LTB00868NAS2

TECHNICAL BULLETIN

SUBJECT/CONCERN:Front Seatbelt(s) Slow to Retract

MODEL:	MODEL YEAR:	VIN:	ASSEMBLY PLANT:
LR4 (LA)	2010-2014	510178-747648	Solihull

Component location.

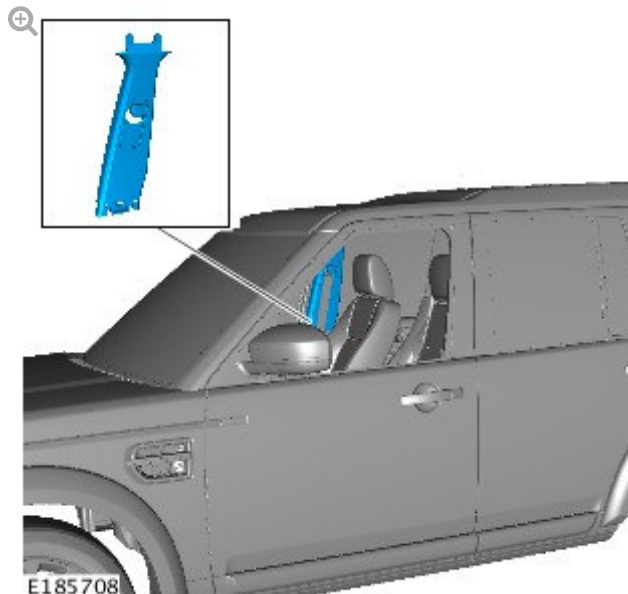
This may be caused by the design of the upper B-pillar trim, allowing the seatbelt to drag on the upper B-pillar trim.

right-side B-pillar shown; left-side B-pillar similar.

4 Install the new B-pillar trim finisher (see TOPIx Workshop Manual, section 501-05: Interior Trim and Ornamentation).
